Standup 2.0
Label Updates
July 2024

Reason for Change: SBC Gen 1 → Gen 2

Label Placements

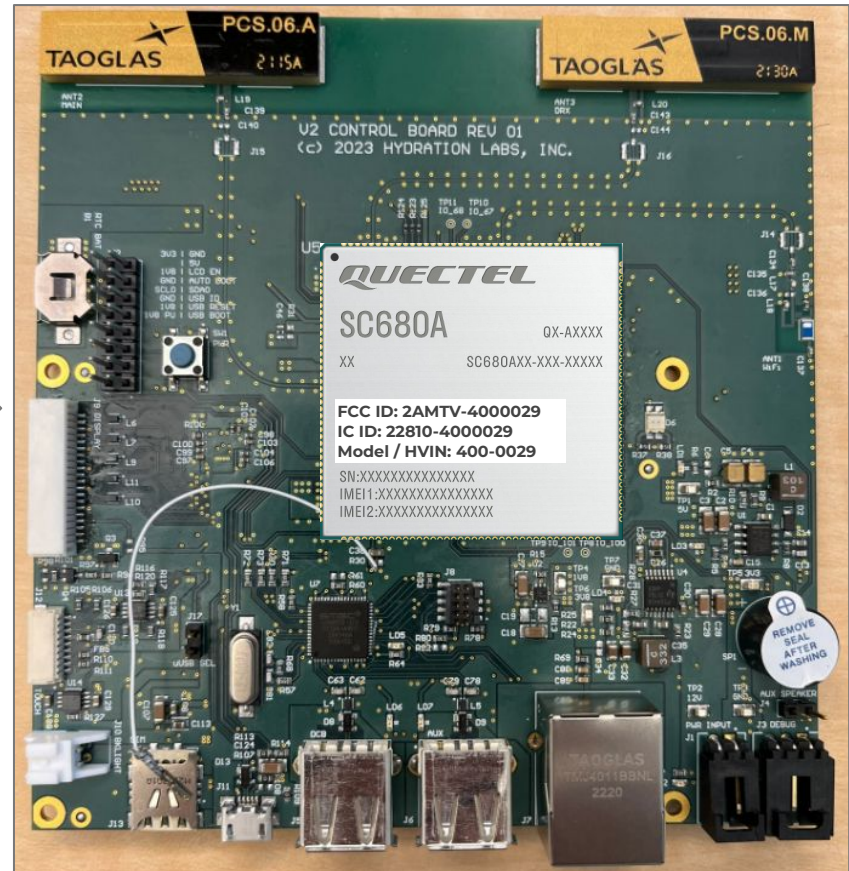
- Needs resizing

- PN: 107460-01
- Can be combined into 1 label

Standup 2.0 Product & Serial Labels

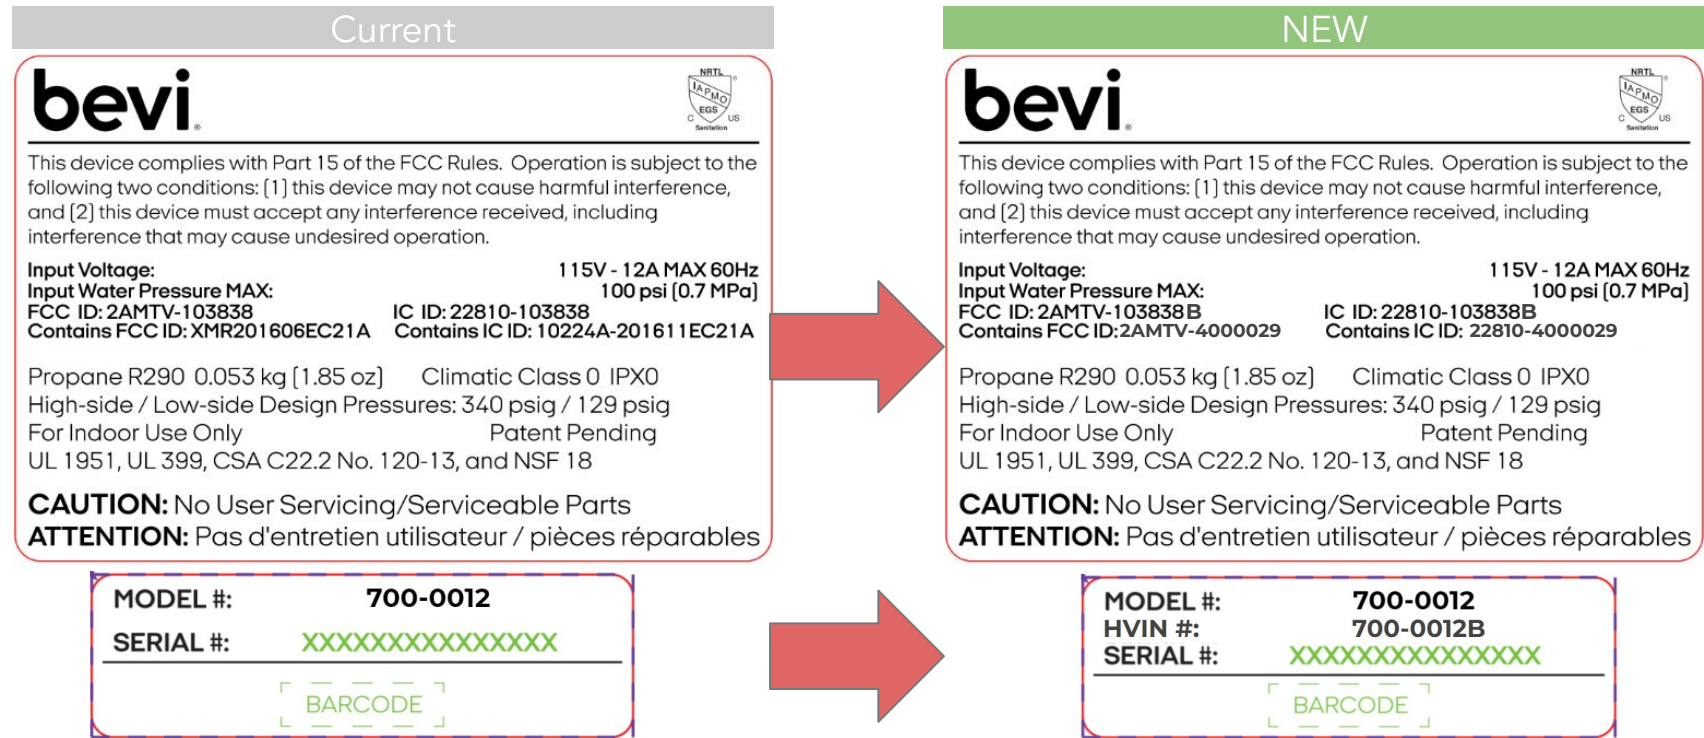
- **Product Label - Bevi PN 107171-01**
 - CHANGE actual FCC ID: 2AMTV-103838B
 - CHANGE actual IC ID: 22810-103838B
 - CHANGE reference FCC/IC ID's for our Gen 2 SBC
- **Model / Serial Number Label - Bevi PN 107461-01**
 - ADD HVIN: 700-0012B

Standup 2.0 Product & Serial Label Placement

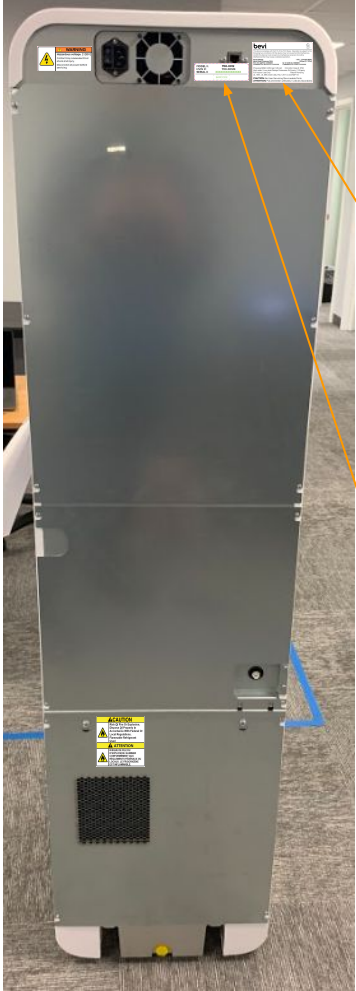
Input Voltage:	115V - 12A MAX 60Hz
Input Water Pressure MAX:	100 psi [0.7 MPa]
FCC ID: 2AMTV-103838B	IC ID: 22810-103838B
Contains FCC ID: 2AMTV-4000029	Contains IC ID: 22810-4000029

MODEL #:	700-0012
HVIN #:	700-0012B
SERIAL #:	XXXXXXXXXXXXXXXXXX
